## ADDENDUM NO. 2

**TO: PLANS AND SPECIFICATIONS FOR STATE OF MISSOURI**

**Sewer Renovations  
Mark Twain State Park  
Florida, Missouri  
PROJECT NO.: X2333-01**

01 SUPPLY VALVE DETAIL FOR  
TYPICAL STANDARD MANIFOLD  
SCALE: NONE

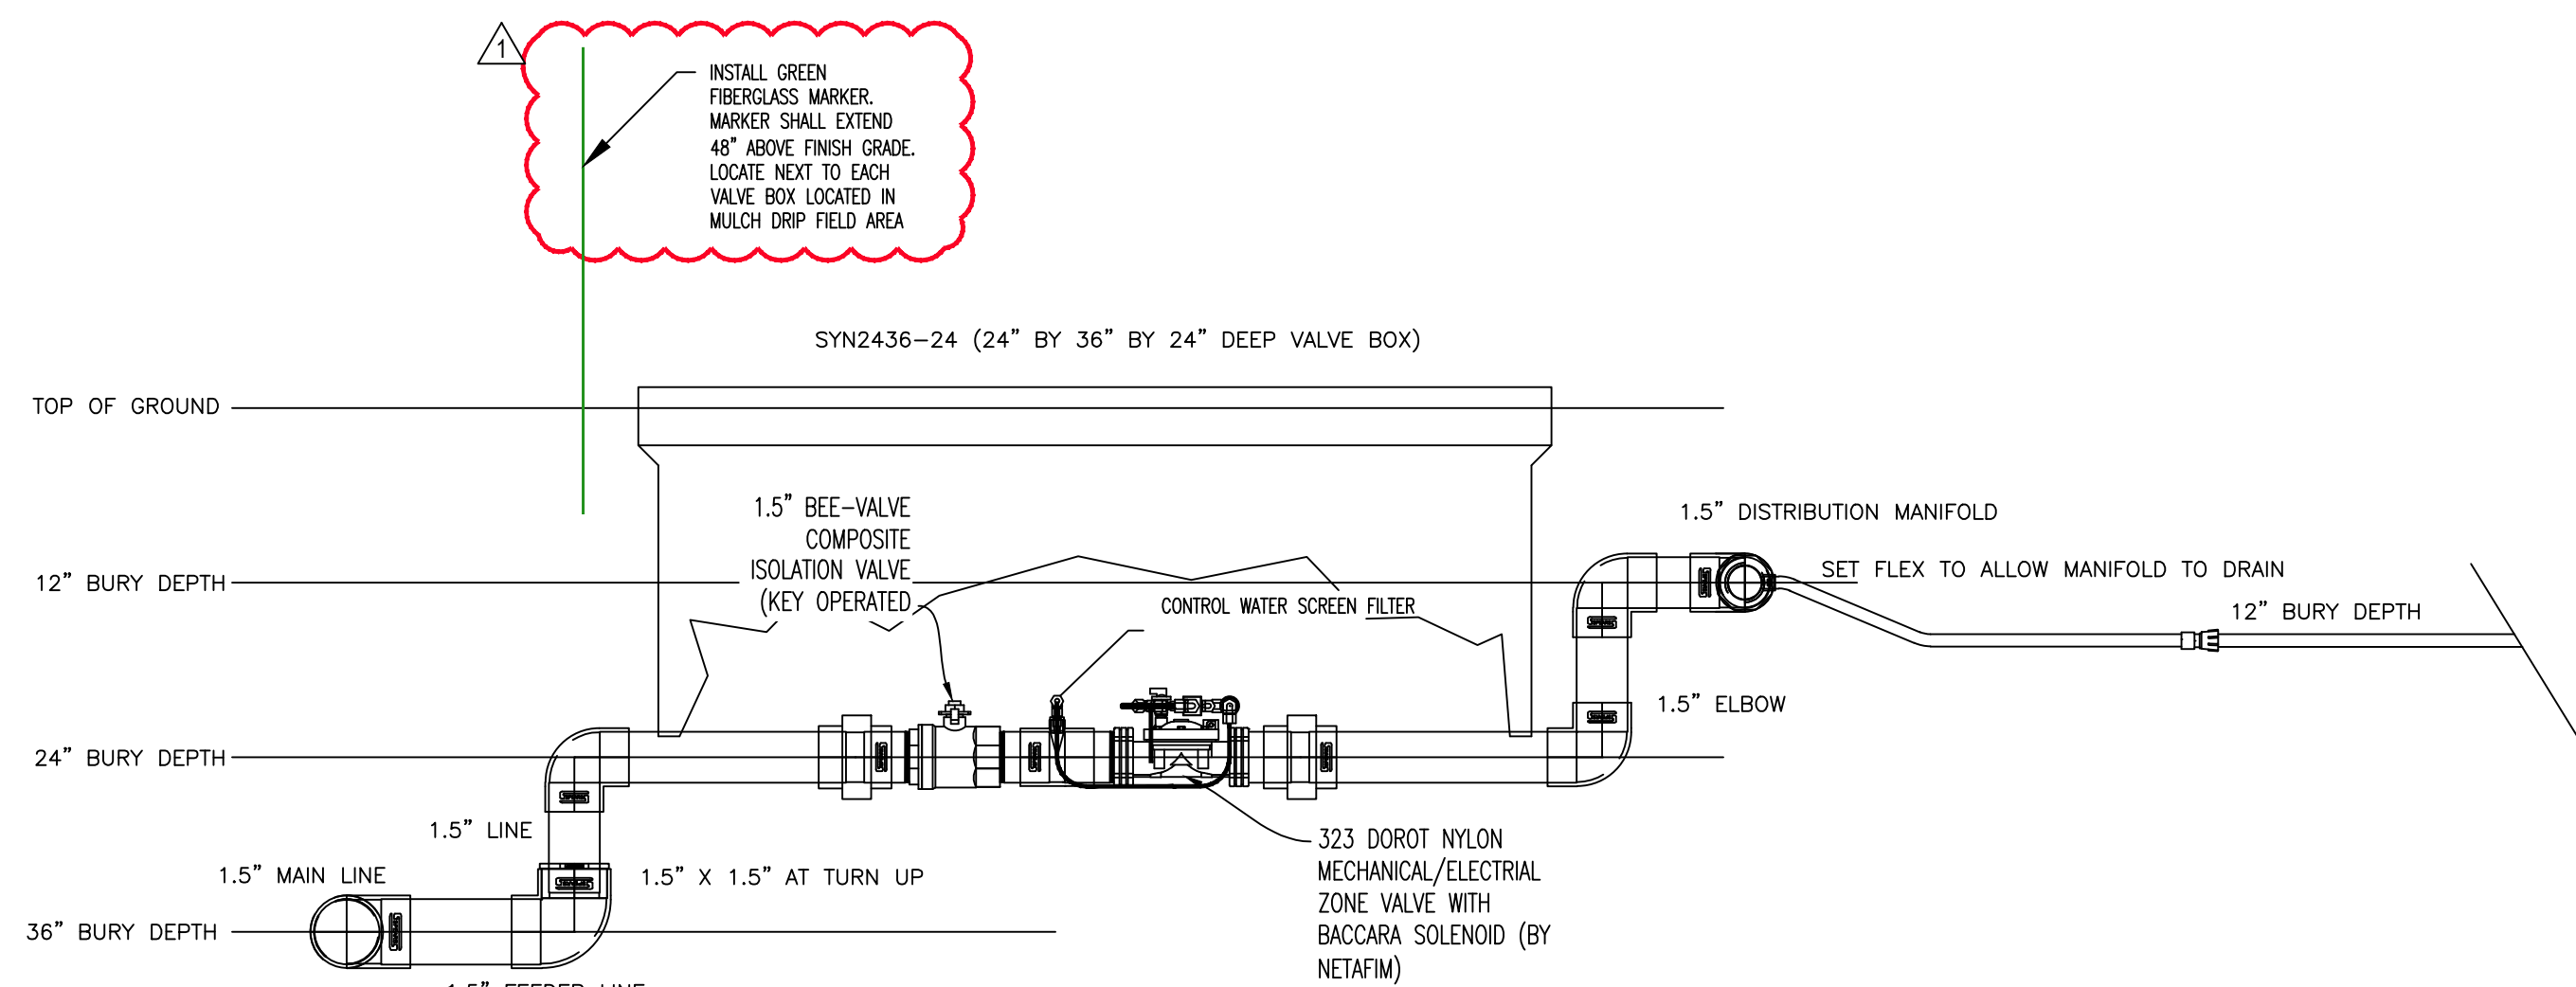
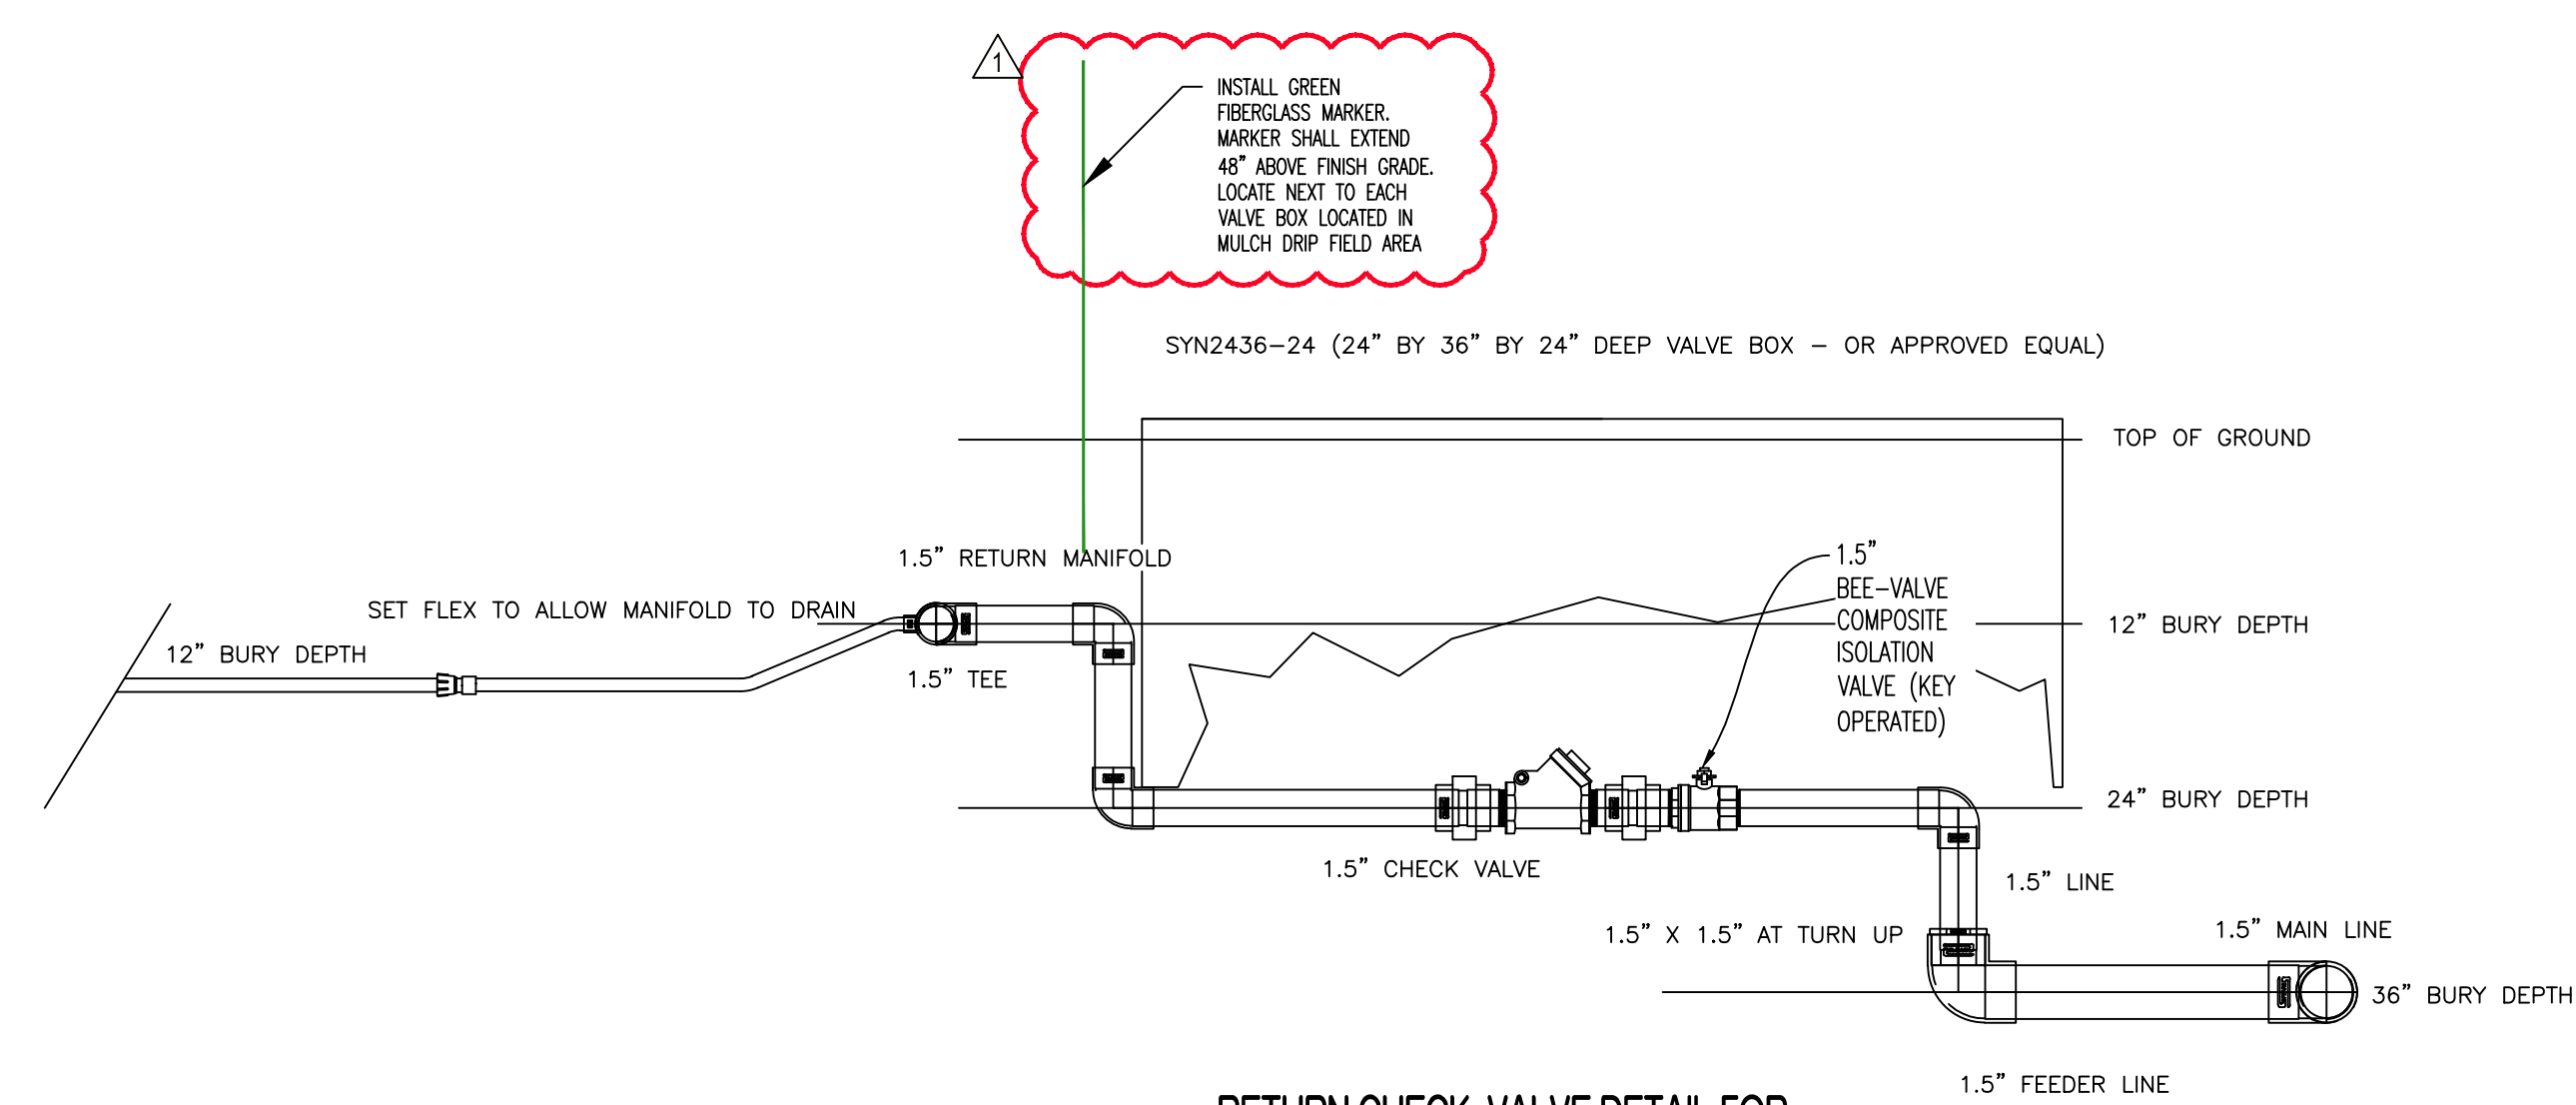
1. Detail 1 and 2 to show fiberglass marker required in mulch areas
